Technical product information

Topic	Steering upright replacement guidelines
Market area	Bentley: worldwide (2WBE)
Brand	Bentley
Transaction No.	2032307/5
Level	EH
Status	Approval
Release date

Continental GT and Continental GTC

Figure 1

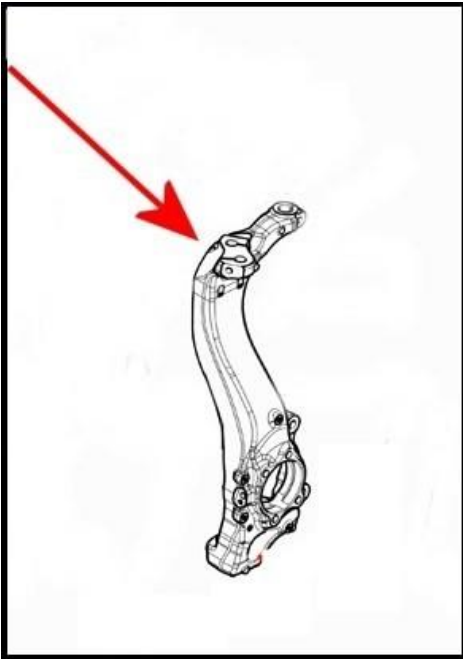
In the event a steering upright is required to be replaced - Refer to the onward instructions (Figure 1)

Refer to the table shown below (depending on model) with regard to any replacement of the front steering uprights

In the event the vehicles current parts are at the specified level and regardless of the side in which the parts are fitted, both sides **MUST** be replaced

If one side already has the specified level part fitted, only the affected side needs to be replaced
